Origination Form
Proposed Revisions to a Standard Plans Index

Originator:	Saha, Dibakar	Index Number:	654-001
Date:	7/7/2025	Sheet Number(s):	1
E-mail:	dibakar.saha@dot.state.fl.us	Index Title:	Rectangular Rapid Flashing Beacon Assembly

LAST REVISION 11/01/23	DESCRIPTION: 11/01/25		FY 2025-26 STANDARD PLANS	RECTANGULAR RAPID FLASHING BEACON ASSEMBLY	INDEX	SHEET
					654-001	1 of 2

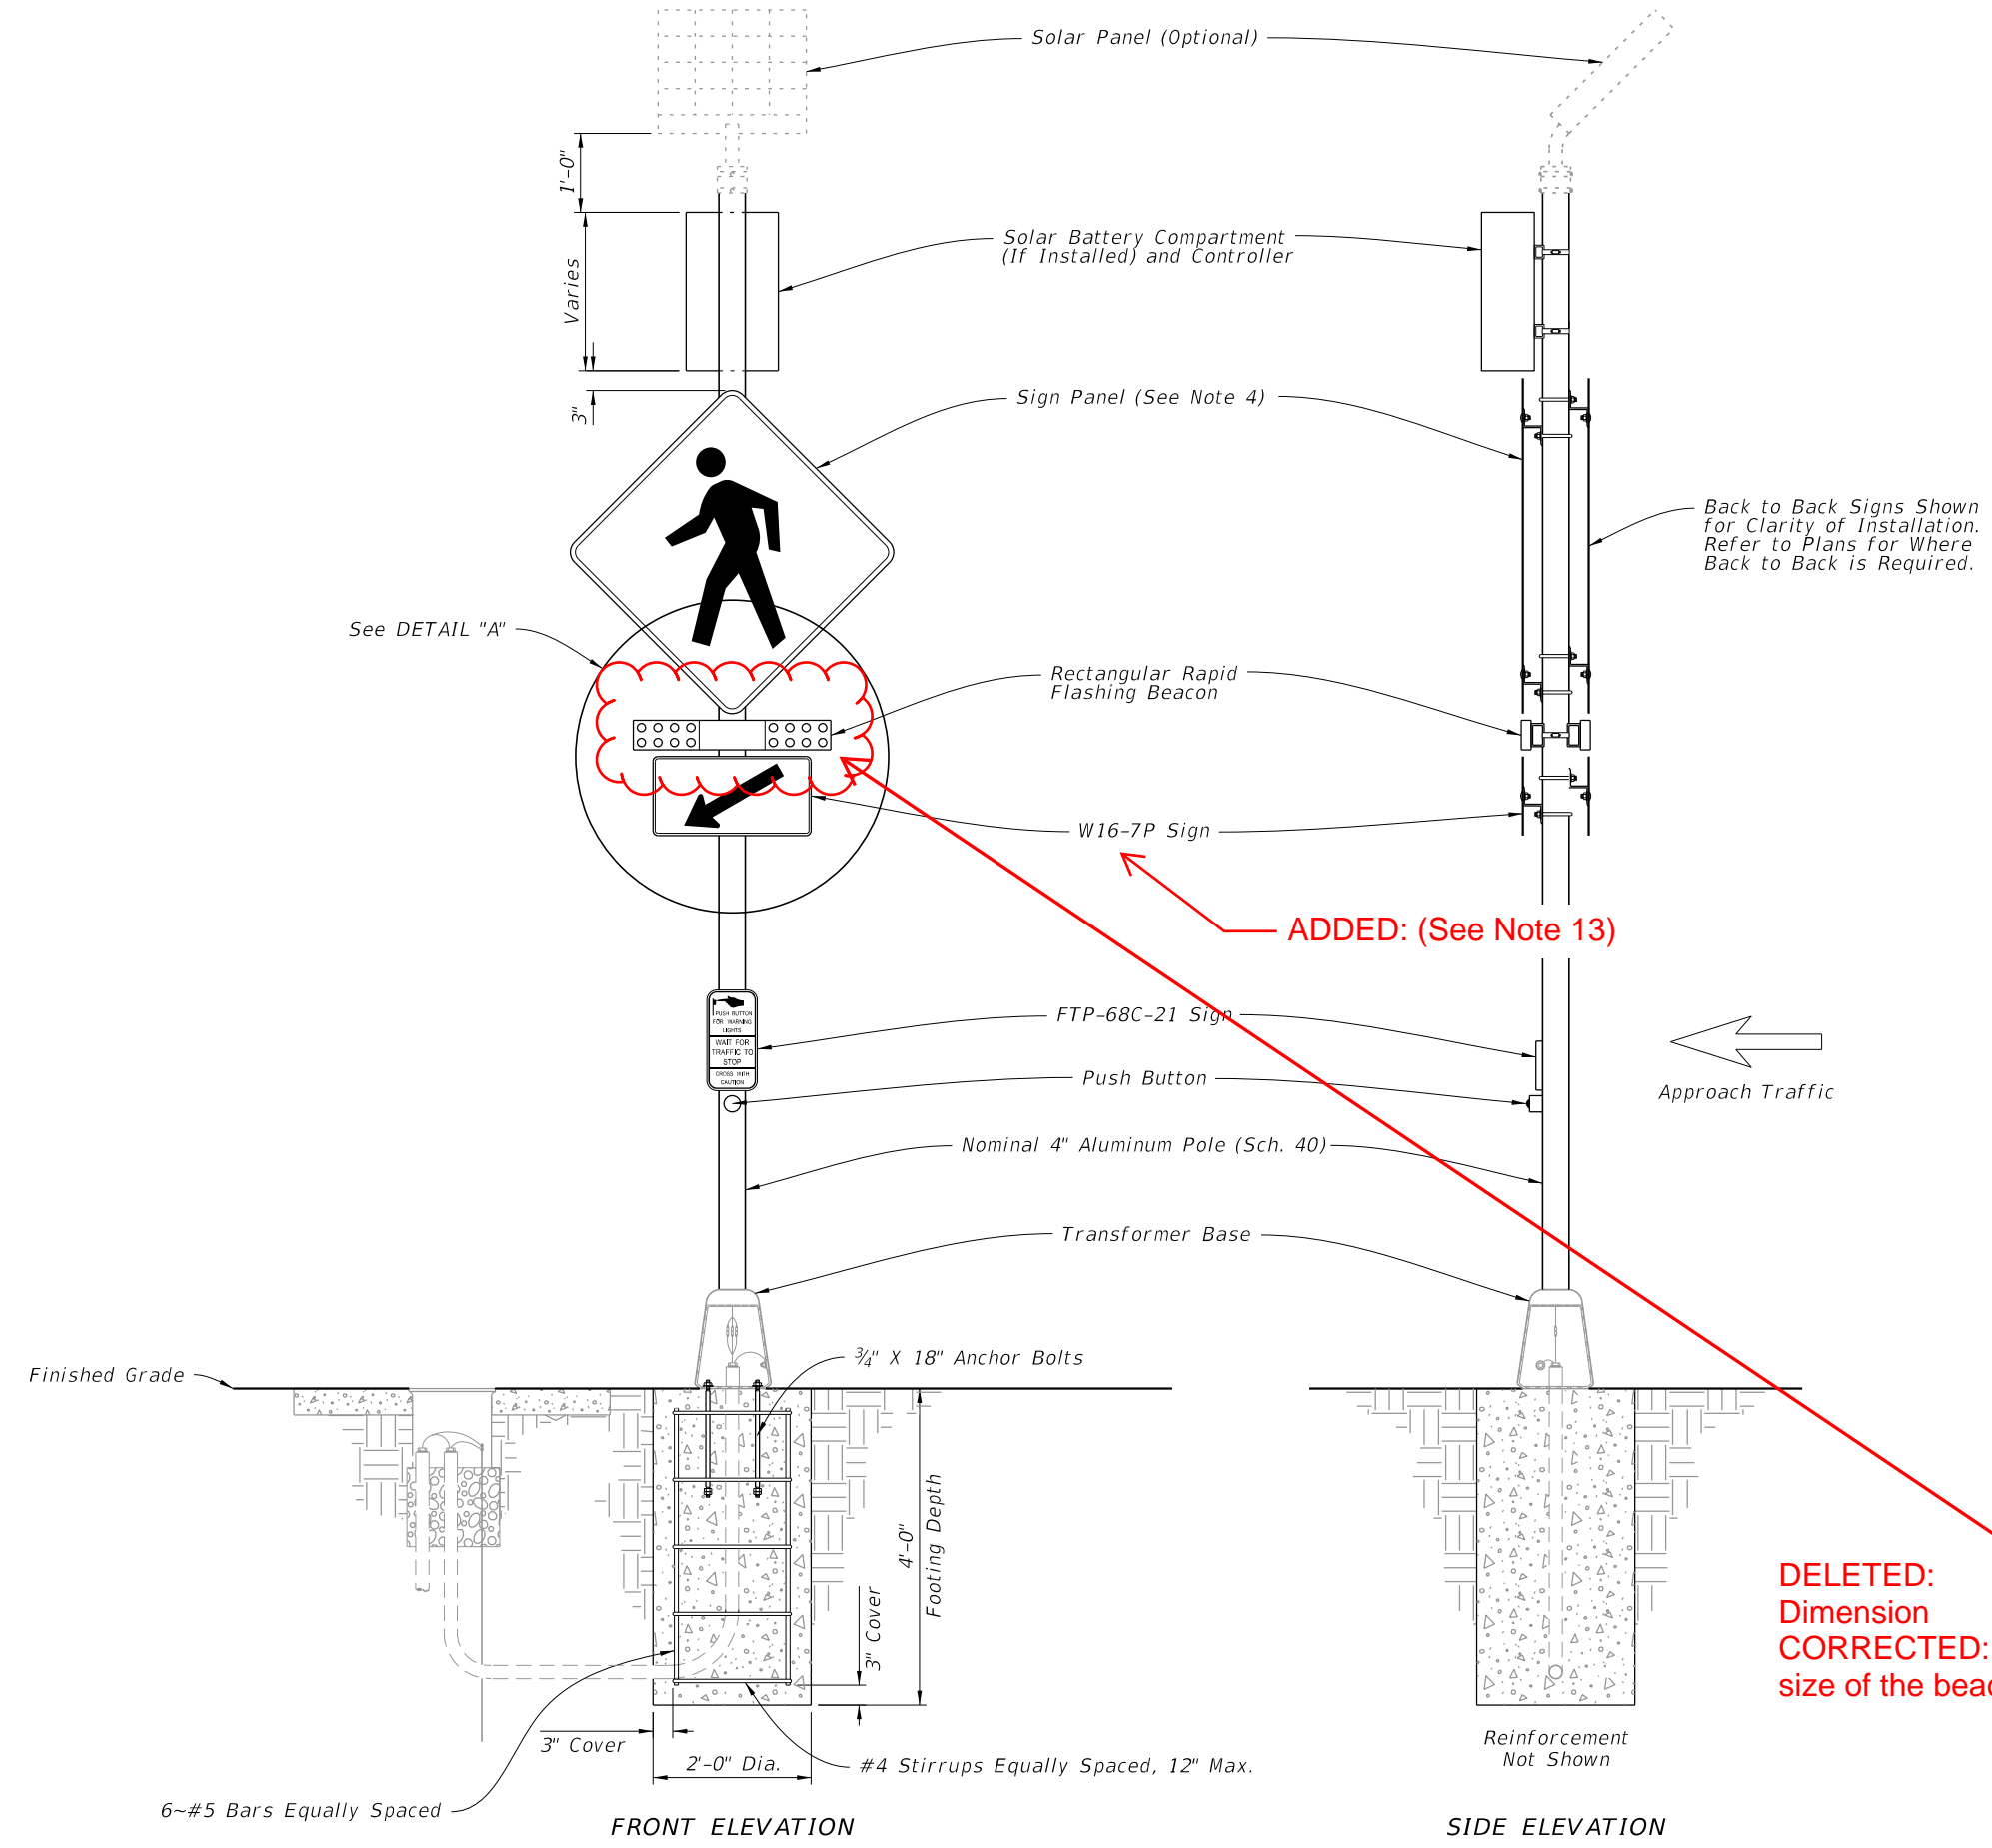
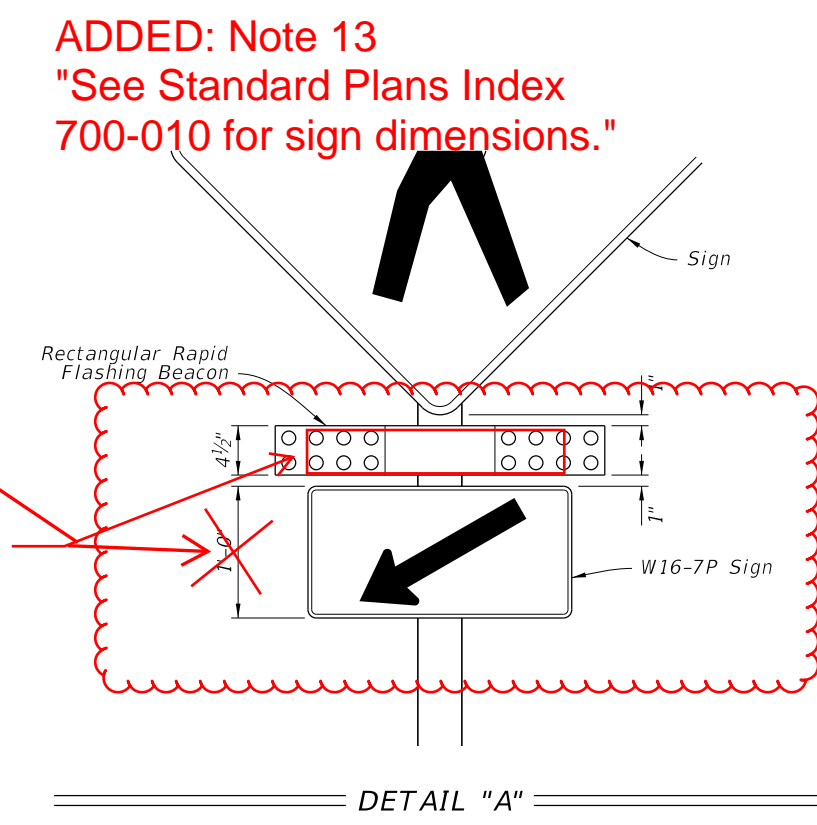
Sheet 1: Deleted the 1'-0" dimension and corrected the size of the beacon in FRONT ELEVATION and DETAIL "A"; Added Note 13 "See Standard Plans Index 700-010 for sign dimensions."; Added "(See Note 13)" to the W16-7P Sign in the ADJACENT TO SIDEWALK Detail.

**DELETED:
Dimension
CORRECTED:
size of the beacon**

Updated W16-7P and Rectangular Rapid Flashing Beacon (RRFB) depiction to more accurately represent dimensions. As W16-7P dimensions depend on the size of W11-2 sign panel, a note 13 was added to send the user to Standard Plans Index 700-010 for the appropriate dimensions.
